KEMET Customer Change Notification CCN-020112-CWF Nickel Plating & Black Epoxy

Change Description

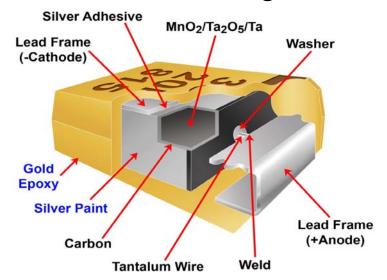
KEMET's Tantalum MnO2 Surface Mount Capacitors are currently manufactured using silver filled resin to build the counter-electrode of the part. The silver application is the final layer of the counter-electrode. KEMET's Tantalum SMD capacitors are also currently built with gold epoxy encapsulation material. See image below.

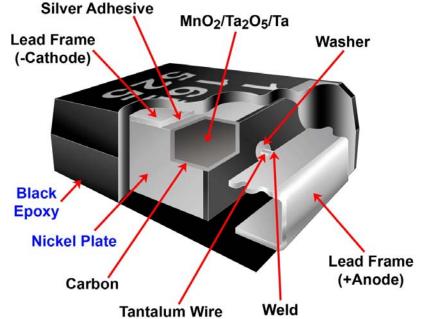
The silver filled resin currently used to build the counterelectrode of KEMET's Tantalum MnO2 Surface Mount Capacitors is being replaced with electro plated nickel. KEMET will also change from gold epoxy to black epoxy concurrently with the nickel plating change. See image

ESR Stability – Additional Data

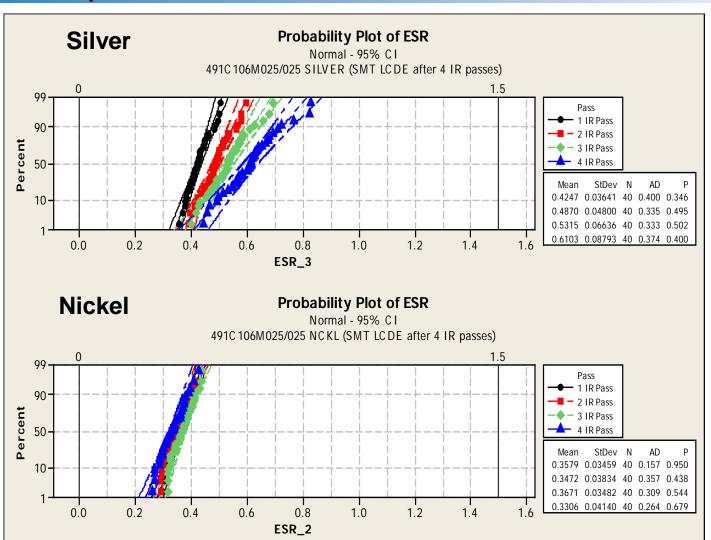
• ESR Stability – Nickel plated product exhibits improved ESR stability post multiple lead free reflow passes as noted below.

ESR Stability after 4 IR passes:

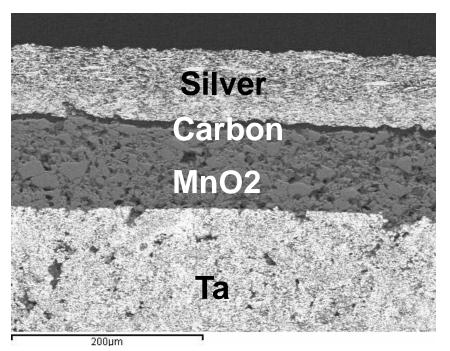
- Ag Paint: 260 mohms increase.
- •Ni Plating: no increase

MnO2 –Nickel plated cathode

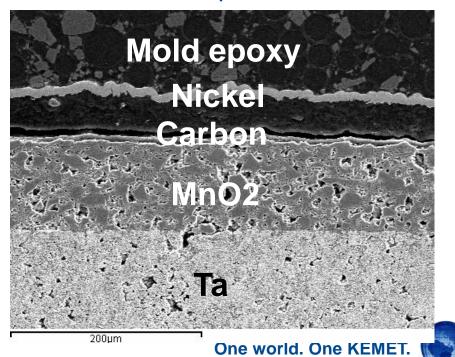
- Electro plated nickel results in a continuous metallic layer which prevents thermo mechanical stress from being transferred to the cathode layers. This prevents ESR shift due to delamination.
 - MnO2 Silver cathode

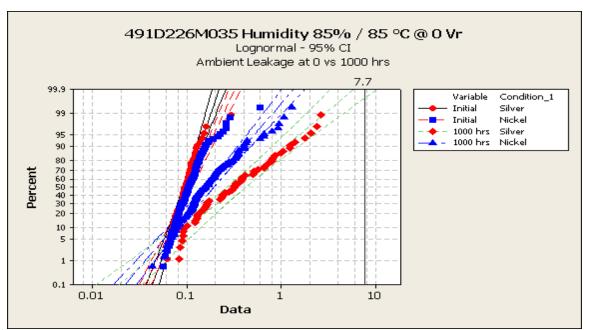
• DC Leakage improvement – Historically, there have been issues noted in the industry related to leakage failures caused by silver migration under high humidity conditions. Replacing the silver with nickel eliminates the source of this failure mechanism.

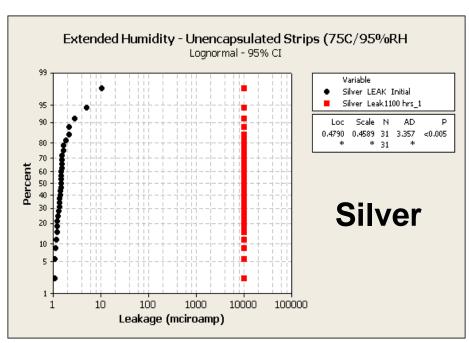
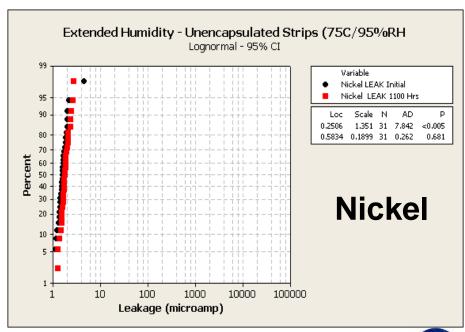
• The leakage improvement is further evidenced below with the impact of silver migration under highly accelerated humidity conditions as compared to the stability of the nickel plated product under like testing.
